Kerferd Rd, Montague St,
Herbert St - Intersection,
Albert Park

Road Safety Audit

Audit Stage: Existing Conditions

Report for City of Port Phillip

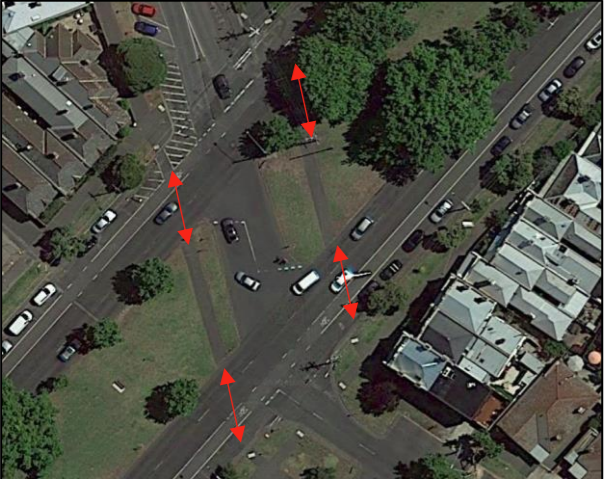
4.1 Sight Lines for Vehicles Exiting Median					
<p>1. There are a number of issues hampering sight lines for vehicles exiting the median into the side roads. These include the dynamic visual obstruction possibility, the angle and the trees. These are described in more detail below:</p> <p>Dynamic Visual Obstruction (masking) Because Kerferd Road is two lanes, there is potential for a dynamic visual obstruction (masking) type issue. The sketch below shows that the yellow van, and the three cyclists would be hidden by the white van for the vehicle exiting the median. If vehicles were banked back from the signalised intersection, or if the masking vehicle was further back on Kerferd Road, the vehicle exiting the median may take a hard acceleration and collide with the yellow car, or the cyclist.</p>  <p>An additional issue related to the dynamic visual obstruction associated with the dual lanes is the high cognitive load on a driver exiting the median. The driver is required to be alert to two traffic lanes, one cyclist lane and pedestrians crossing the side road.</p>	<p>Occasional Serious High</p>	<p>Exceeds tolerable levels (important)</p>	<p>Consider the options presented on page 9 and 10 above, with the preferred option from the Auditors being:</p> <ul style="list-style-type: none"> Close the median break (P)

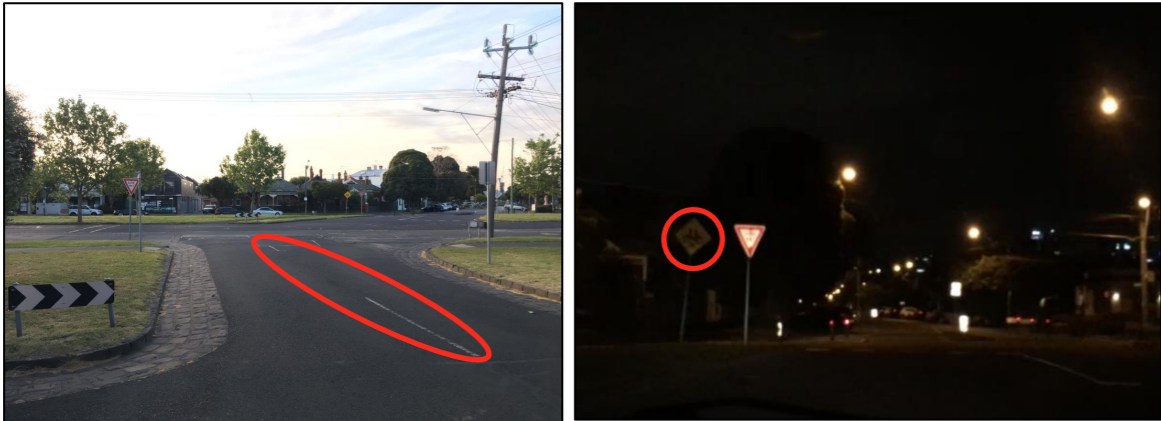
Audit Findings	Level of Risk	Safe System Energy	Recommendations P – Primary ST – Step Towards S – Supporting N – Non-Safe System	Responsible Officer	
				Accept Yes/No	Comments
<p>Angle Within the median break, traffic lanes intersect with Kerferd Road on a skewed angle (greater than 90 degrees) with a Give-Way condition. Angles greater than 90 degrees can be difficult for some motorists to turn their heads far enough to observe through traffic.</p>  <p>A potential front seat passenger may impede a motorist's sight line as they are forced to observe traffic from behind their shoulder, in line with said passenger.</p> <p>Trees An established tree line is also present in close proximity to the roadway impeding sightlines to smaller road users such as motorcyclists and cyclists.</p> <p>A motorist may fail to observe a through vehicle, these issues compound to increase the likelihood of failure to Give-Way crashes.</p> 	(...continued from above)	(...continued from above)	(...continued from above)
